**Northcrest Flex Space PPR PCD No. PPR2412**

Re: **Northcrest Business Center: Traffic Memorandum**  
El Paso County, CO

**DEVIATION REQUEST  
AND DECISION FORM**

Table 1

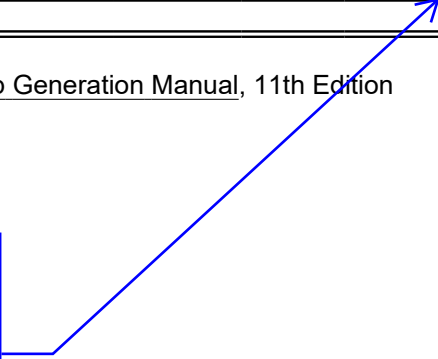
This does not match ITE use and Table #1 below

Update Site Trip Generation using 1000sqft GFA Gross Floor Area not 100s of units. The average traffic for 100s of unit is considerably lower based on much larger self storage unit complexes in the 500-1000 unit unit range. Traffic using GFA is more realistic based on the studies for ADT and peak hrs for the size of the planned 62K sqft storage complex

1 DEVELOPMENT SITE PLAN  
DP.02 SCALE: 1" = 20'-0"

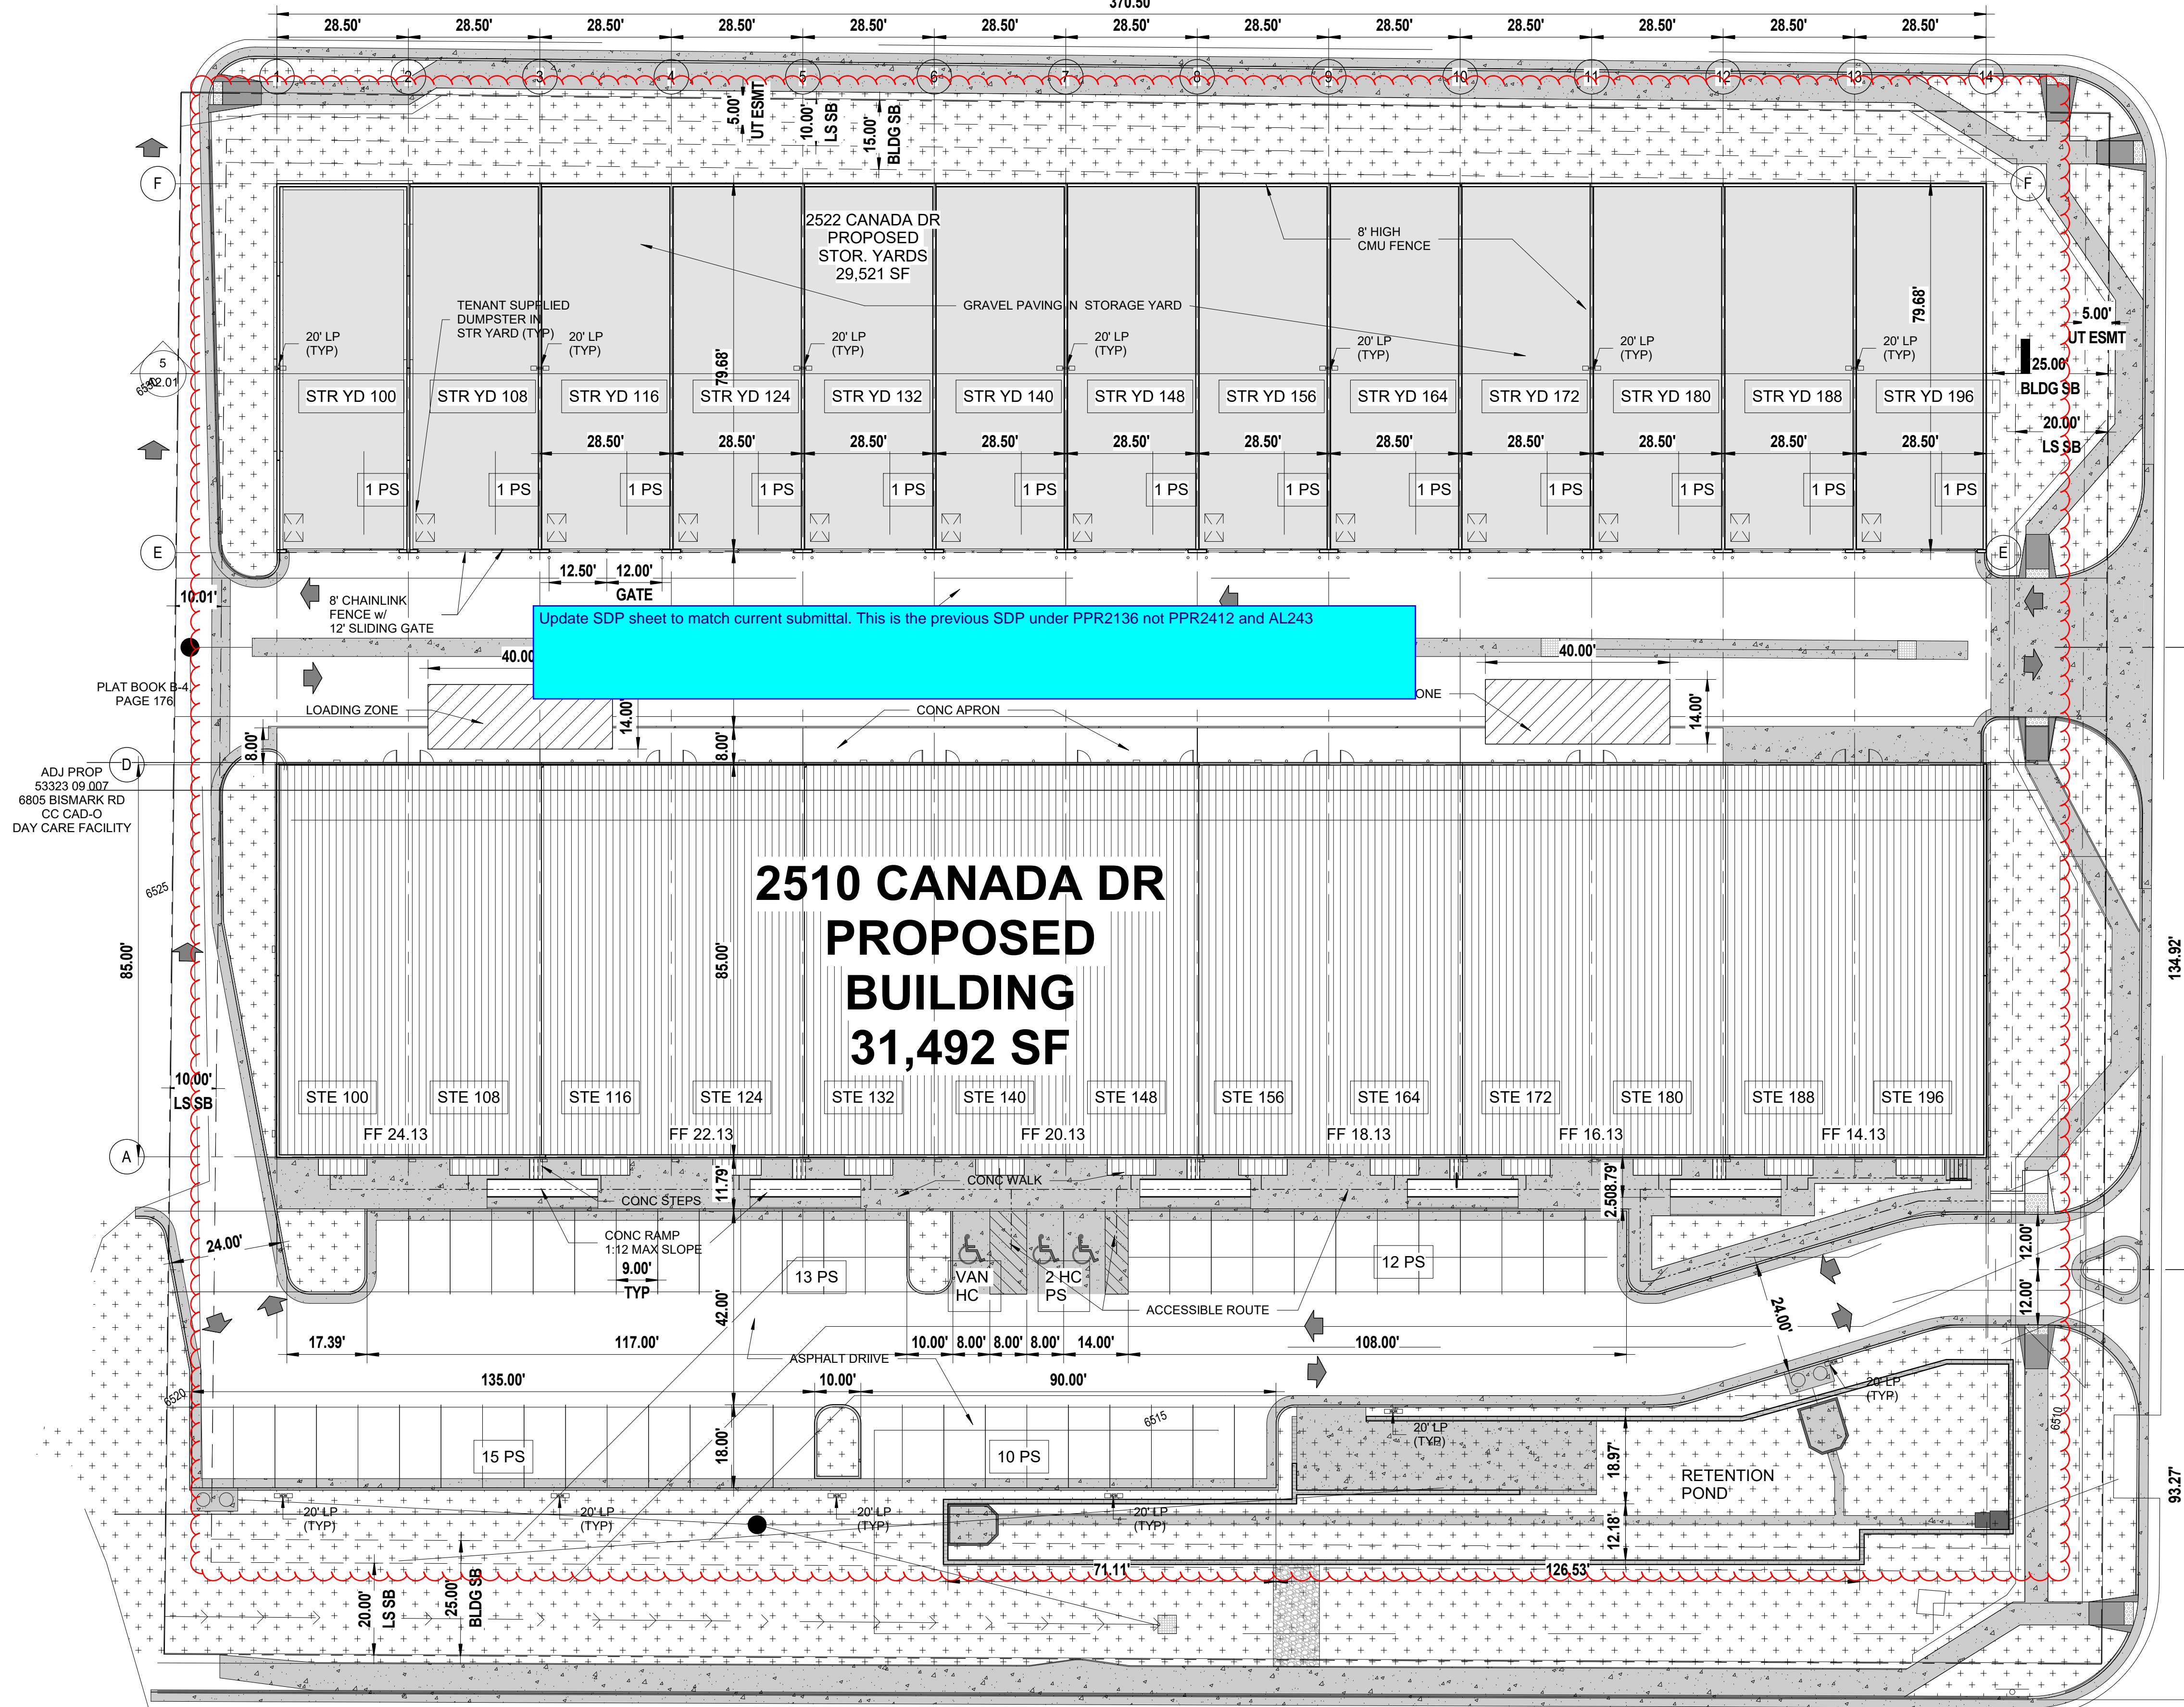
No shared access is shown on new proposed SDP

no shared access please update and correct based on current proposed SDP
